FINAL ENVIRONMENTAL IMPACT REPORT – Volume 2

SFPUC Southern Skyline Boulevard Ridge Trail Extension Project

PLANNING DEPARTMENT
CASE NO. 2016-016100ENV

The purpose of this responses to comments (RTC) document is to present comments on the draft environmental impact report (draft EIR) for the proposed San Francisco Public Utilities Commission (SFPUC) Southern Skyline Boulevard Ridge Trail Extension Project (project), to respond in writing to comments on environmental issues, and to revise the draft EIR as necessary to provide additional clarity. Comments were made in written form during the public comment period from June 25, 2020 to August 10, 2020, and as oral testimony received before the San Francisco Planning Commission at the public hearing on the draft EIR held on July 23, 2020. A complete transcript of proceedings from the public hearing on the draft EIR and all written comments are included herein in their entirety. A complete list of commenters is provided in Chapter 10, List of Persons Commenting.

Figure 11.4-1

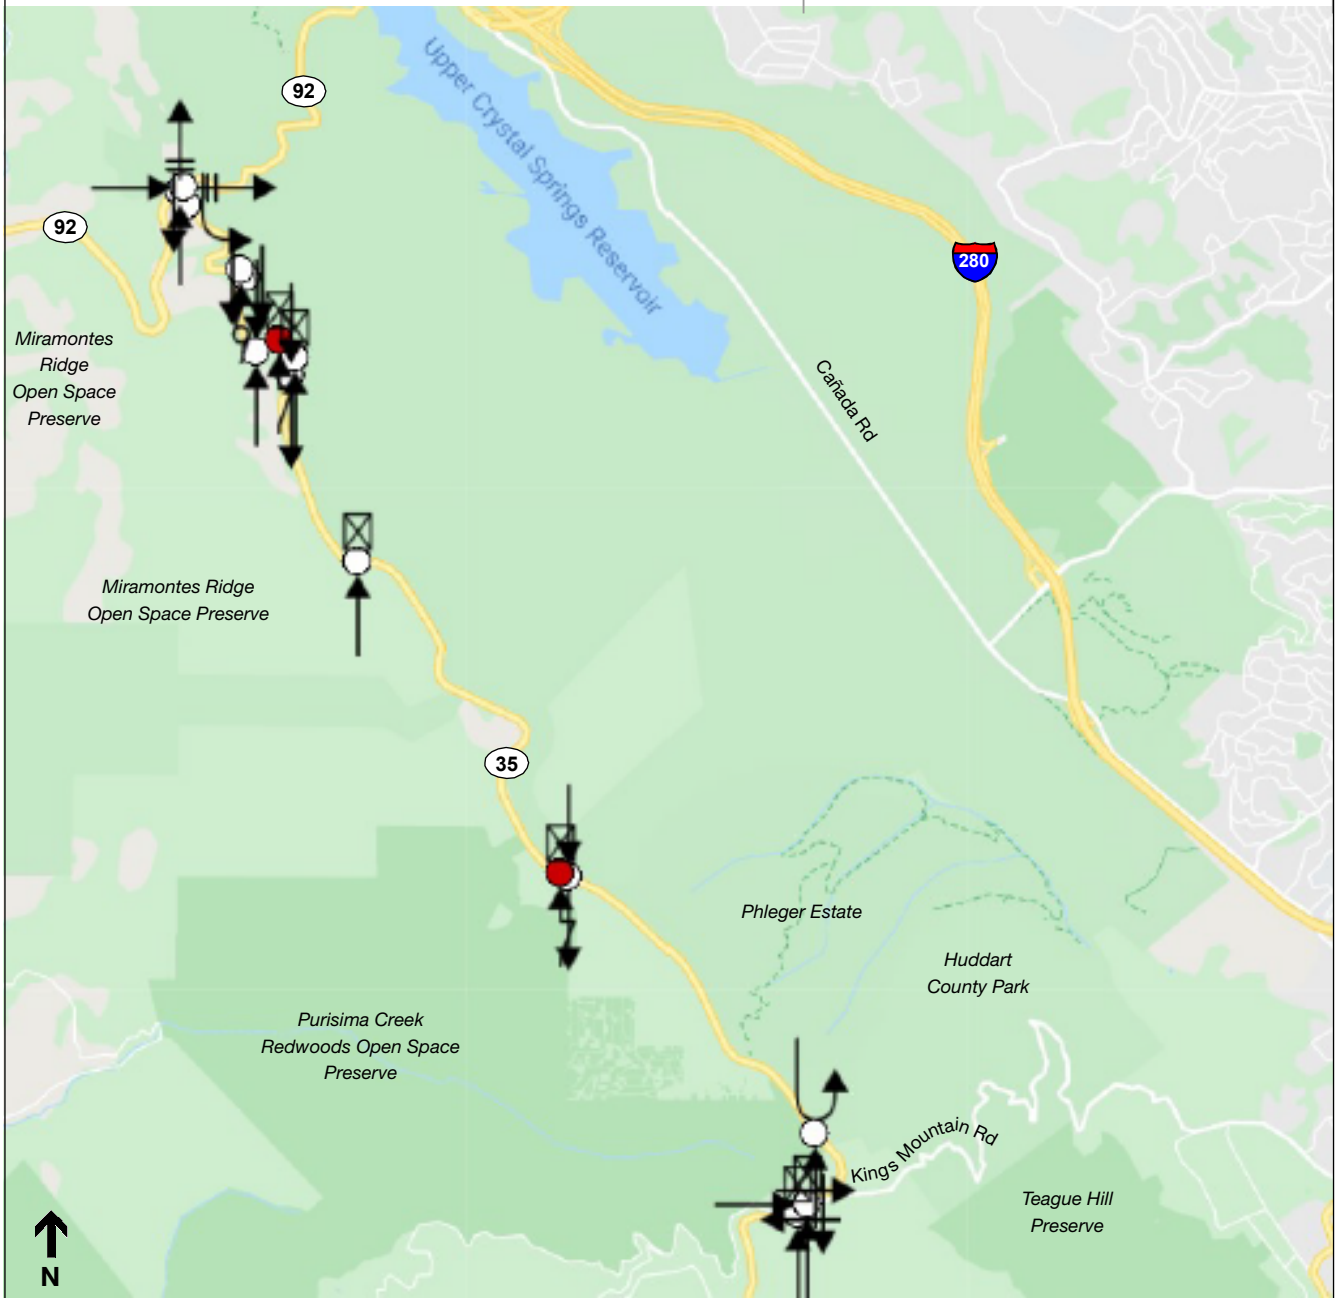
“Lastly, there's no mention in the DEIR of how to mitigate unauthorized parking forming at any of the convening access points” (Jerry Molitor, Planning Commission, Hearing Comments, July 23, 2020)

As shown in **Figure 11.4-1**, six of the 22 collisions involved a parked vehicle, and only one of those occurred at a location near a trail entrance, approximately 1,200 feet to the south of the entrance to the north parking lot. In addition, one of the 22 collisions involved a vehicle making a U-turn near the entrance to the south parking lot.
